PROJECT **123A90 - HOLLANDSE KUST NOORD WIND PARK**
BLPH Project

MECHANICAL COMPLETION DOSSIER (ONSHORE)

SYSTEM	70 Safety and Facility Systems
SUBSYSTEM	70-00-27 Junction Box 950-JE-04207 and Multi-core cable (FGS System)

C30001078

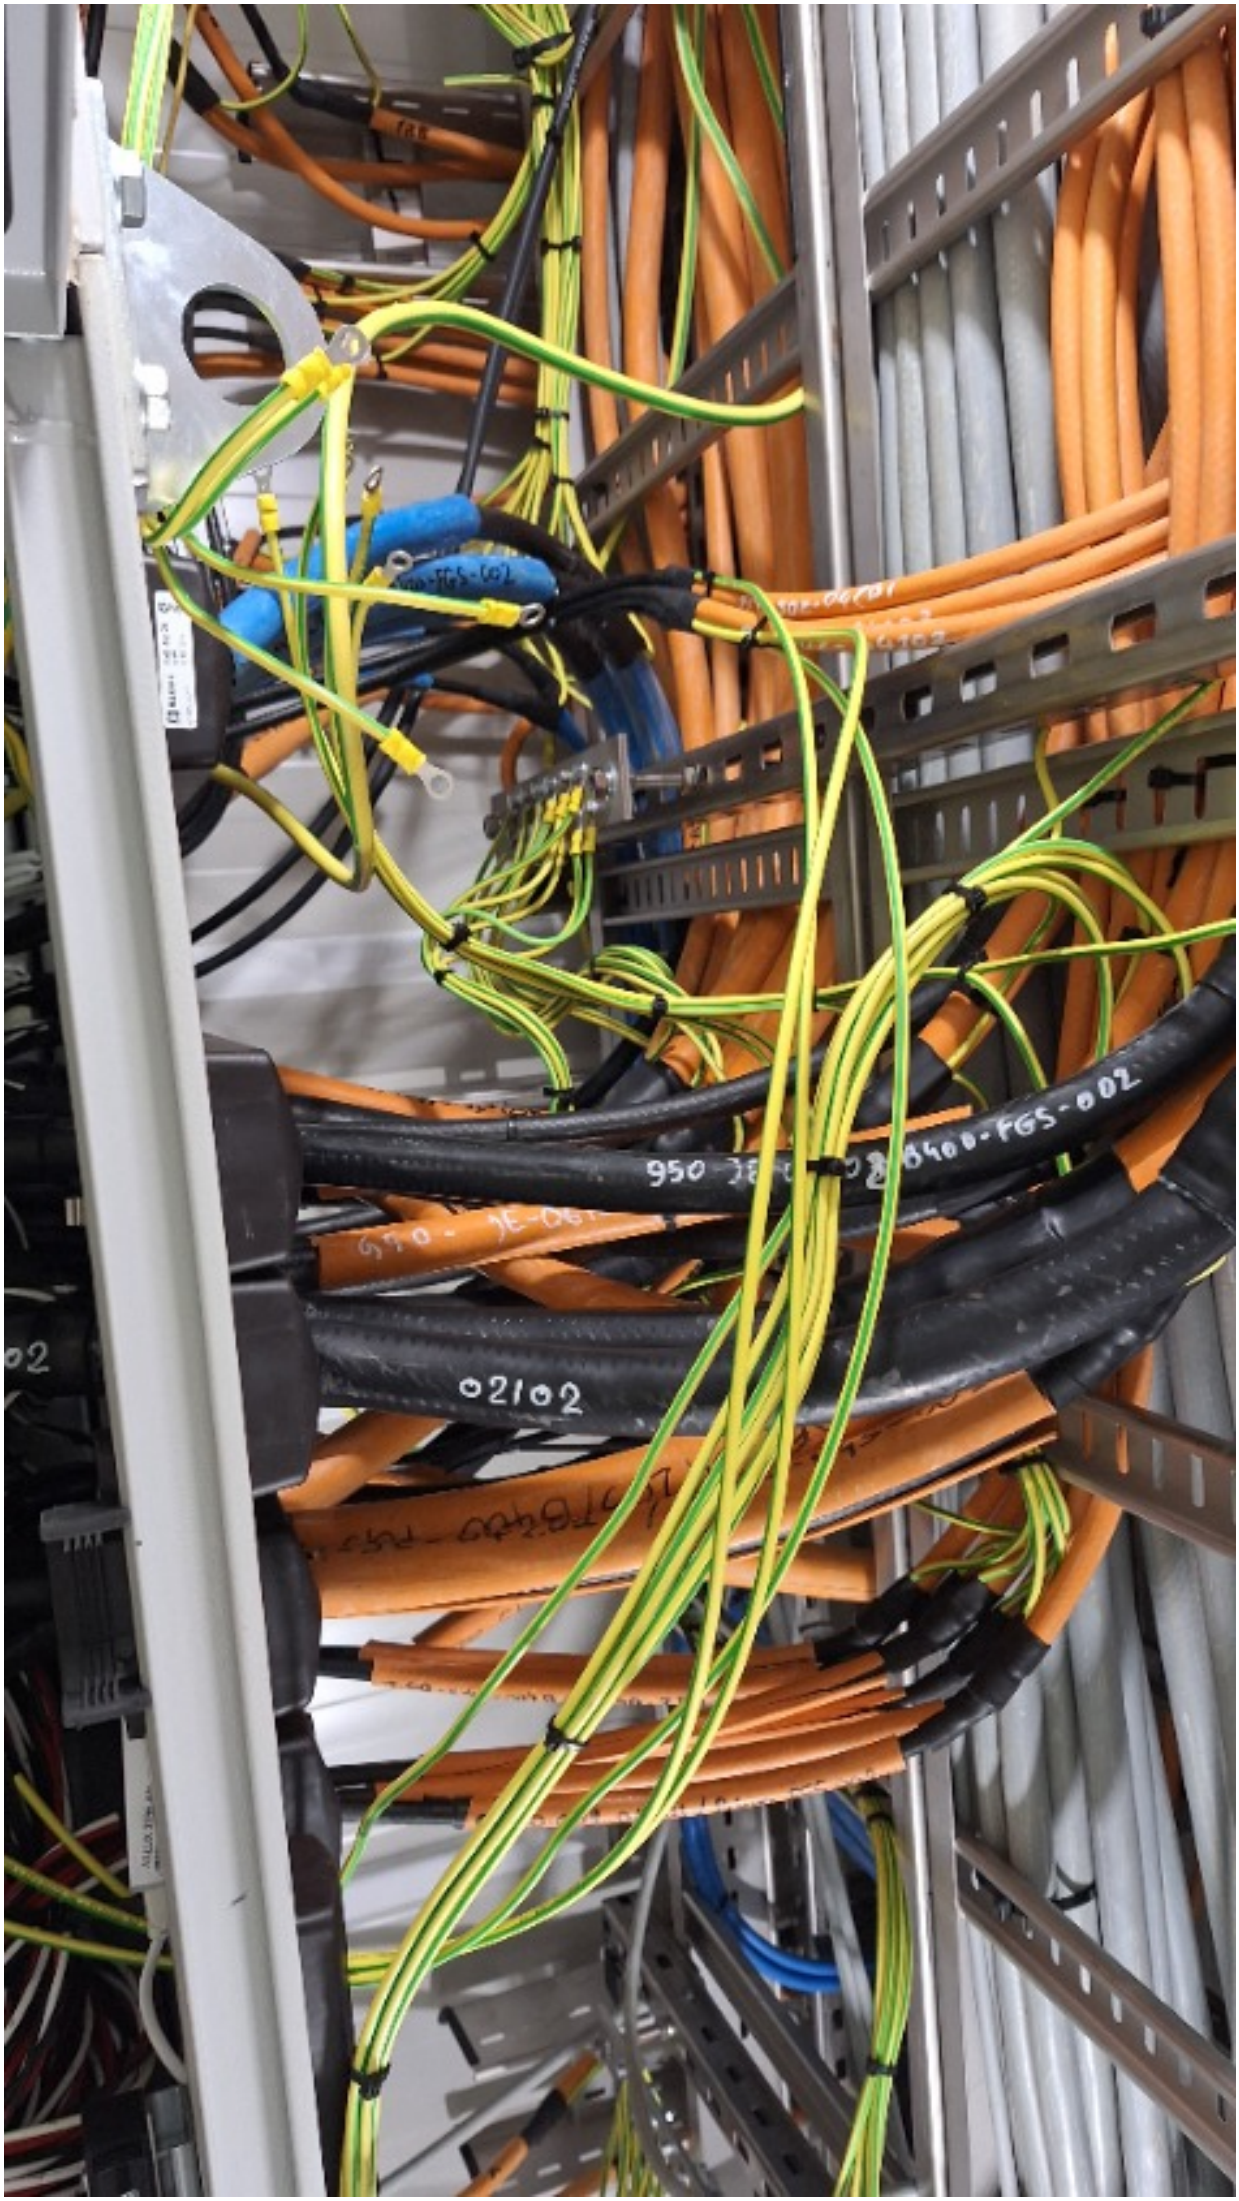
The copper conductor of the cable armor must be individually connected to the earthing bar. See 123A90-DDL-EL-DD-20090.
SIDE B400-FGS-002

DONE

C30001082

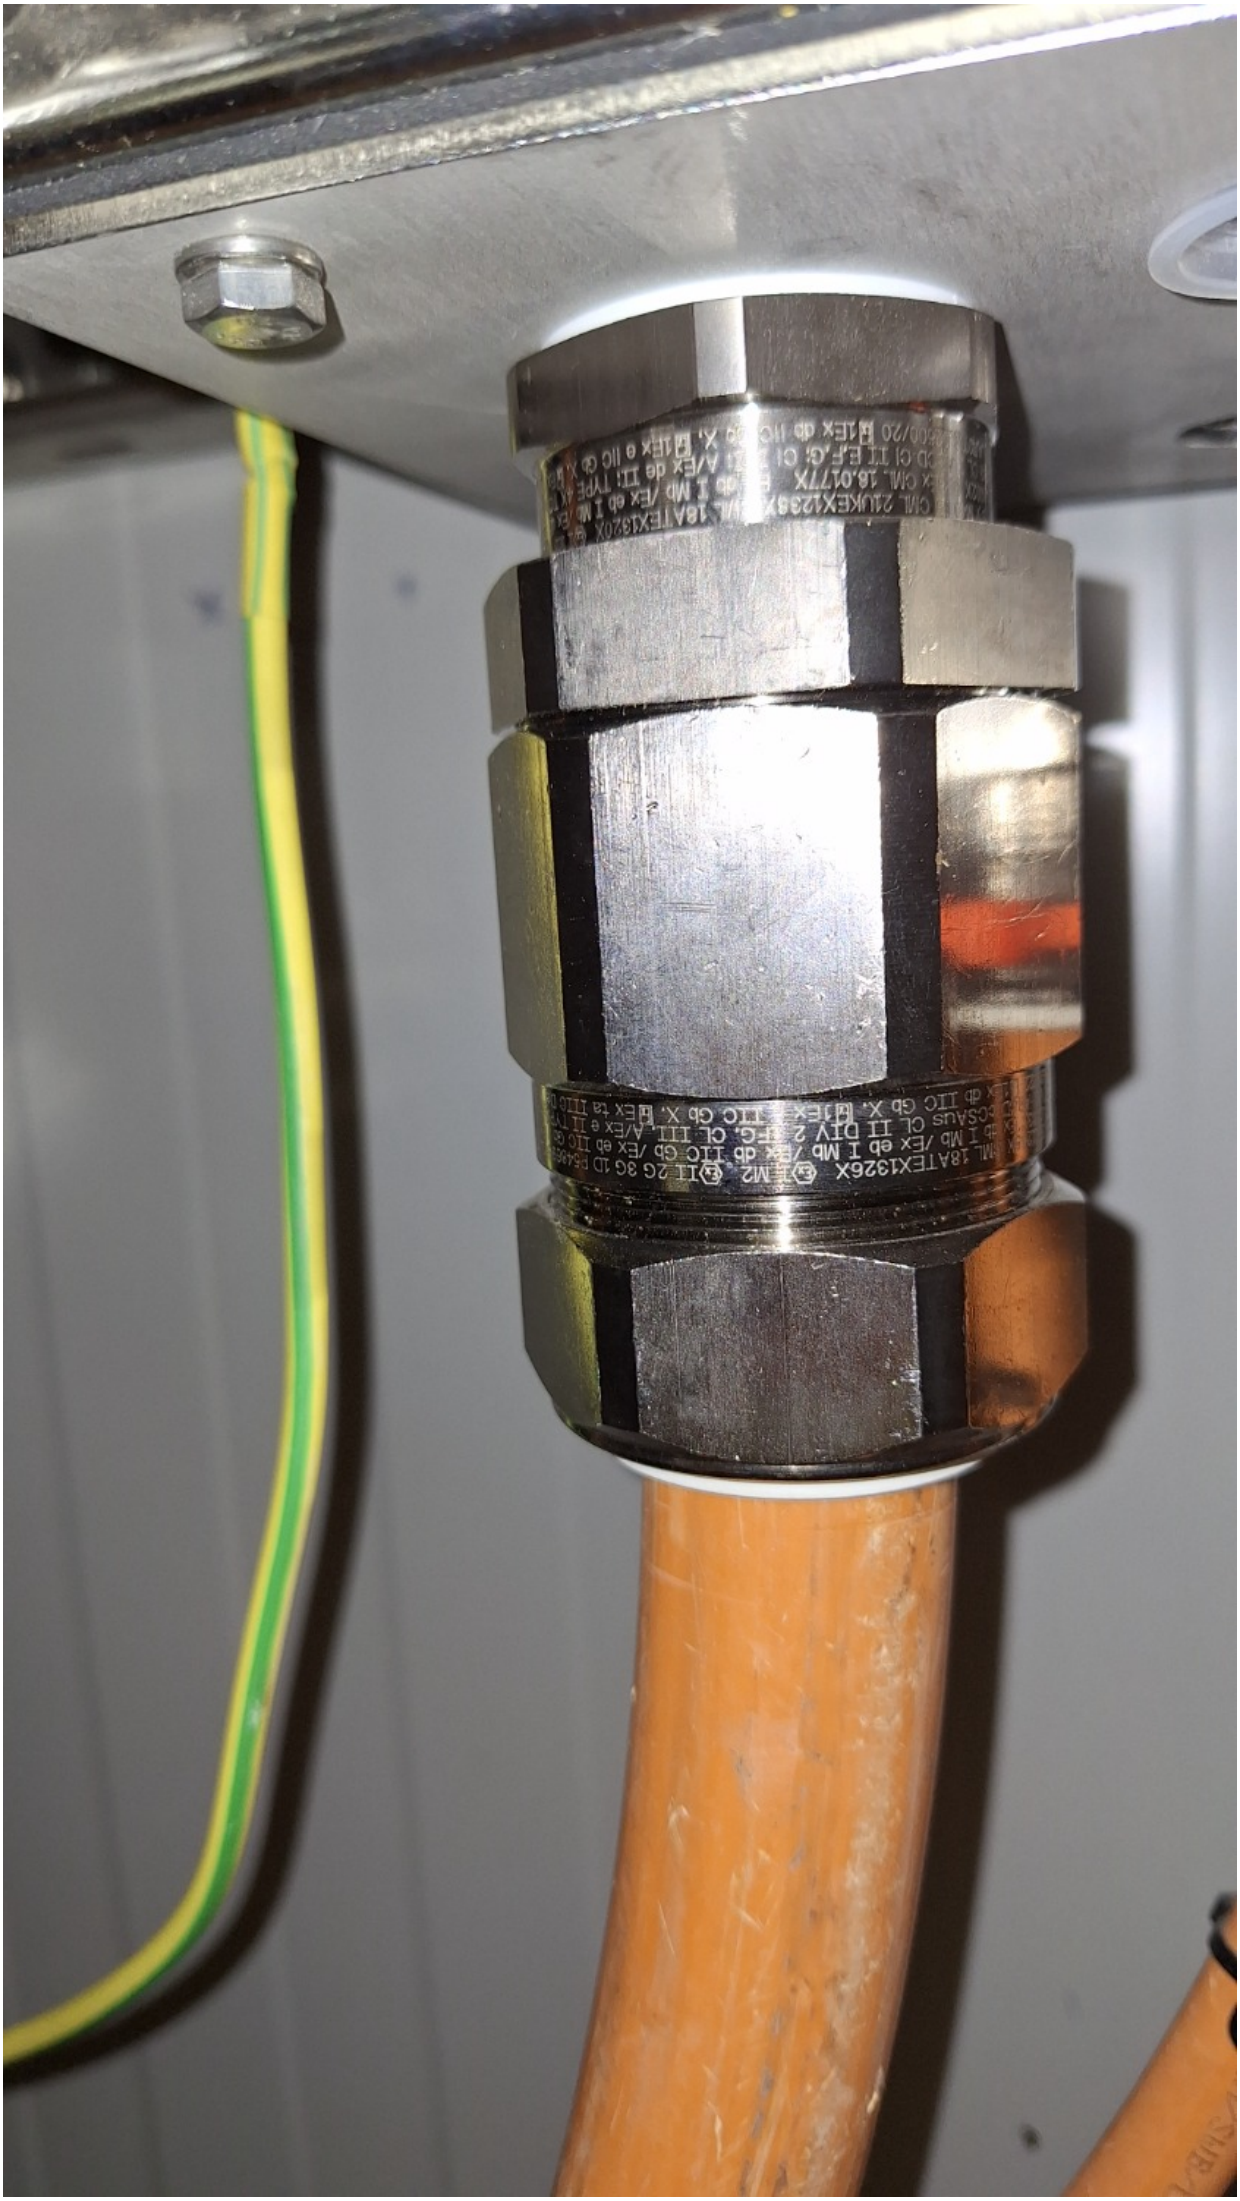
Missing the entry thread seal, between the cable gland and the adaptor. SIDE 950-JE-04207

closed.
